RUSSIAN MARITIME REGISTER OF SHIPPING

CIRCULAR LETTER	No. 314-26-1122c	dated	12.04.2018

amendments to the Rules for the Classification and Construction of High-Speed Craft, 2018, ND No. 2-020101-111-E

Appendix(-ces): text of amendments to Part II "Hull Structure and Strength"

Structural parameters of catamaran

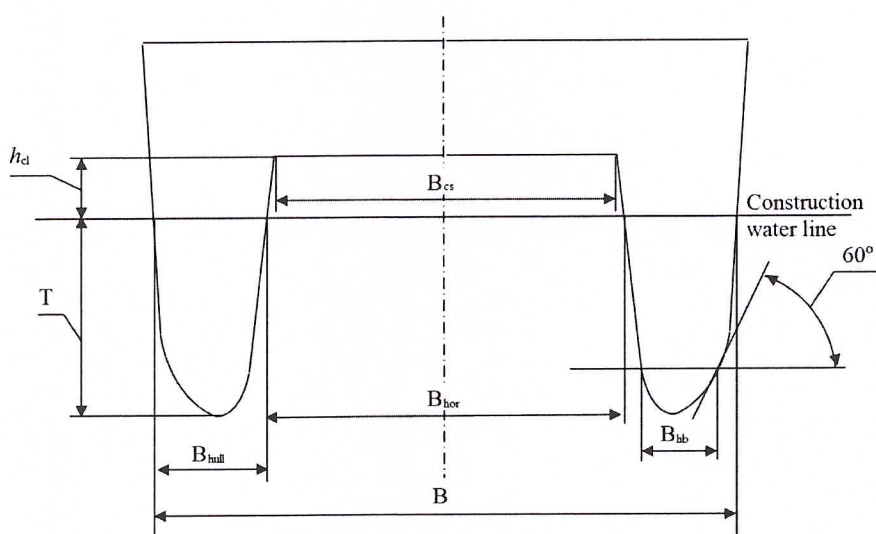
Figure 1.3 "Structural parameters of catamaran" shall be amended to read:

Fig. 5.3.13.2".

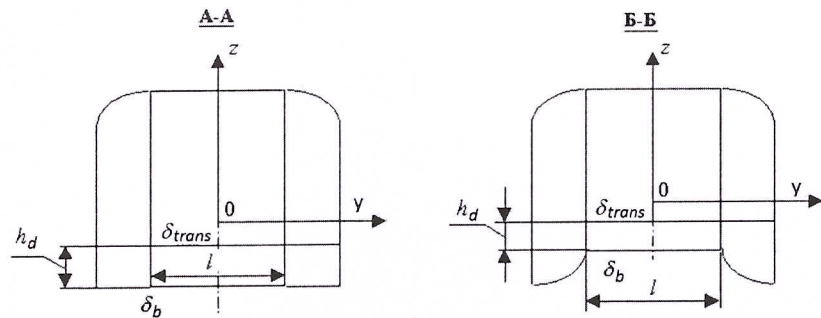
Figure 5.3.13.2. The sections "A-A" and "B-B" of Fig. 5.3.13.2 shall be amended to read:
